Subject: RATTLE NOISE FROM FRONT SUSPENSION WHEN DRIVING OVER BUMPS	Bulletin No.: 02-006/20
	Last Issued: 09/02/2020

2019-2020 Mazda3 (Japan built) with VINS lower than JM1BP*****166377 (produced before January 25, 2020)

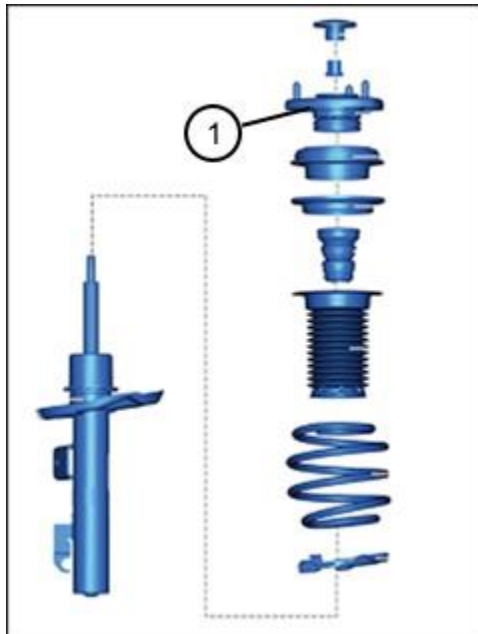
Some vehicles may exhibit a rattle noise from the front suspension when driving over bumps or on a road with a wavy surface. The noise may be caused by the mounting rubber (1) because of insufficient clearance between the rubber and the metal bracket of the mounting rubber during the assembly process. To correct this issue, the mounting rubber has been modified to ensure the proper clearance.

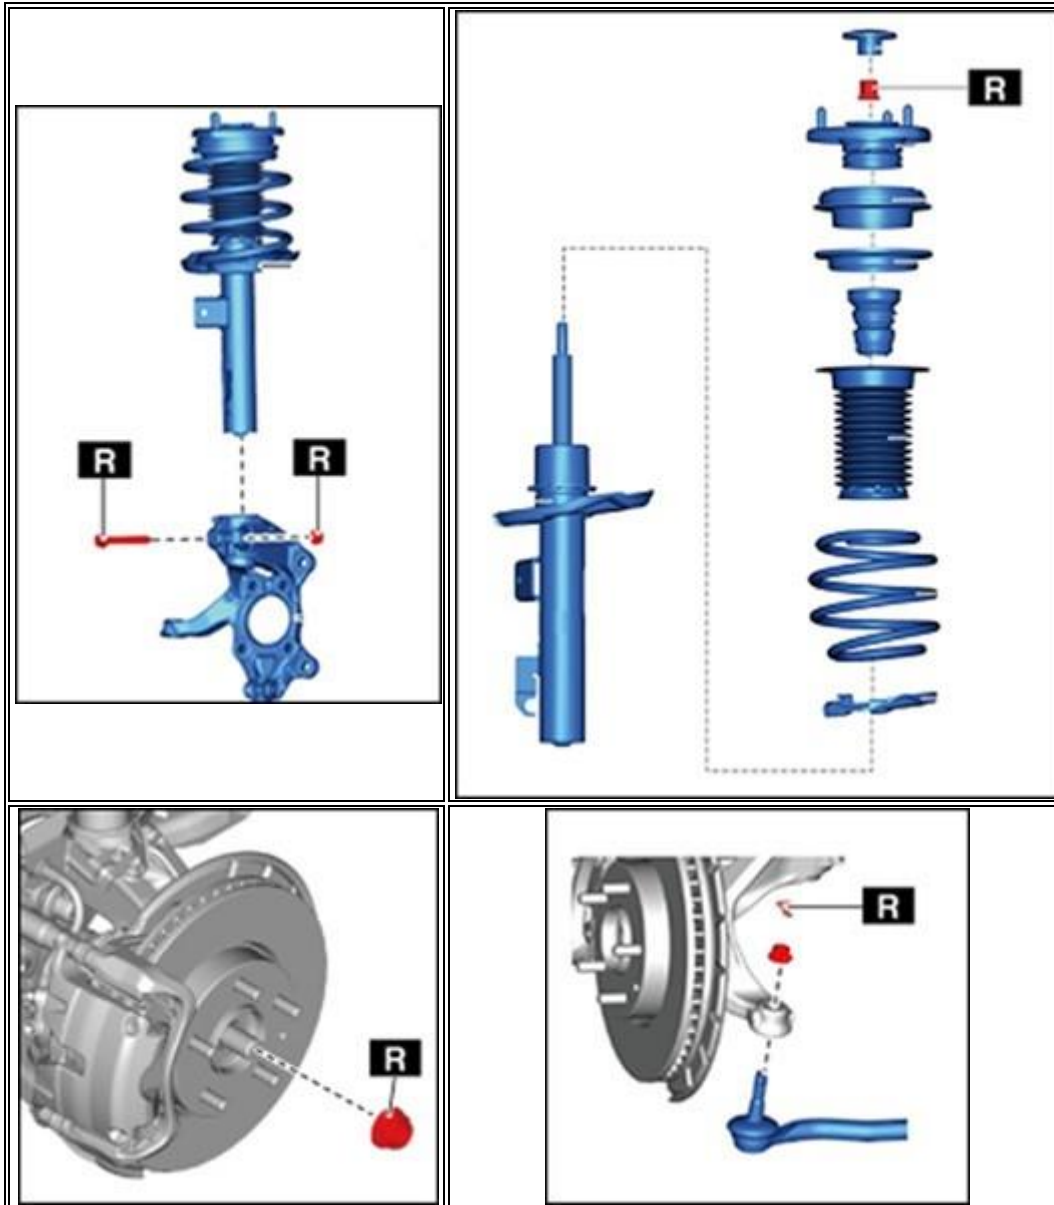
NOTE: Modified mounting rubber BCKE-34-380B is of the same part number as before, but with the production date stamped in white letters on the back of the part. The modification has been implemented from Nov. 21, 2019. Sample picture shows back of the mounting rubber.
